THE WOODS AT VENICE PRELIMINARY PLAT PETITION NO. 17-01PP STAFF REPORT

Owner: The Woodlands at Venice, LLC
 Parcel ID #s: 0393002000, 0394003040 and 0394003020

MAP 5: Proposed Woods at Venice Landscape Plan

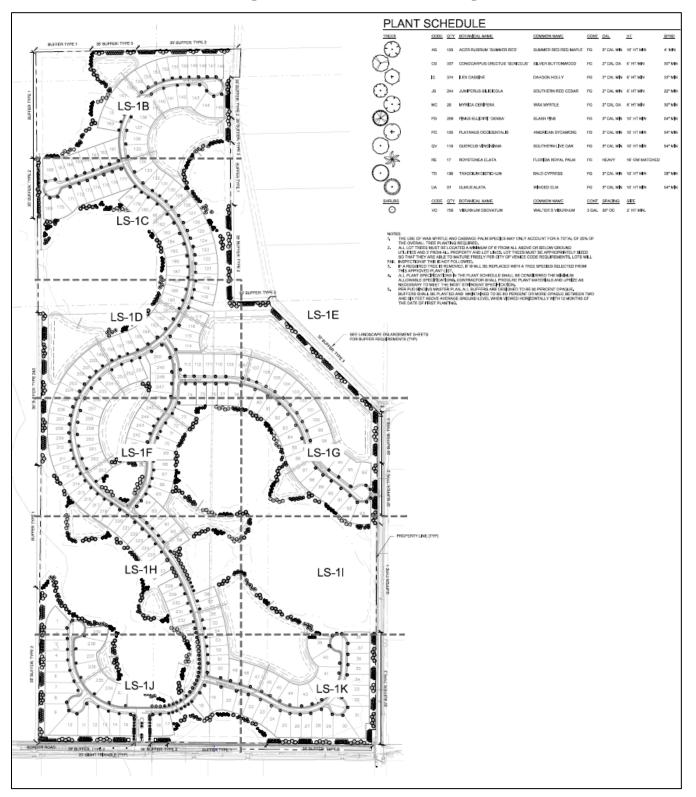
During the review of the preliminary plat it was noted that the landscape plan identified proposed tree plantings in some areas where tree removal may not be justified when this project goes through the tree permit review process. As a result, it is possible that some existing trees may need to be retained and ultimately require modification to the landscape plan. In particular, there may be some open space areas, especially those in the vicinity of the preserved wetlands and buffers, where existing healthy trees could be retained. This would be evaluated during the tree permit review process when this project moves forward for construction plan approval. It is not anticipated that changes to the proposed developed areas or lot configuration would be necessary to address this concern. Staff met with the applicant's team on February 5, 2018 to share this information. It was agreed that a condition be added to the site plans that recognizes no tree removal will be performed until a tree permit is issued, and to recognize that modification to the landscape plan may be necessary in the future. As it was too late to incorporate the notation on the preliminary plat plans for the scheduled Planning Commission hearing, forestry staff has included a stipulation that states:

Require the landscape plan and subsequent construction plans be modified to include the following statement:

Prior to any site preparation or construction activities that result in tree removal, the property owner shall obtain a Tree Removal Permit, consistent with the requirements of the Sarasota County Trees Code, Chapter 54, Article XVIII of the Sarasota County Code; as adopted by the City of Venice through an Interlocal Agreement, recorded in the Official Records of Sarasota County as Instrument Number 91044783. The principles of avoidance and minimization are employed during the Tree Permit review process, which may result in modifications to the preliminary plat landscape plans.

The applicant's team has reviewed this stipulation. The approval of the landscape plan included in the preliminary plat shall not be used as justification for tree removal during the tree permit review.
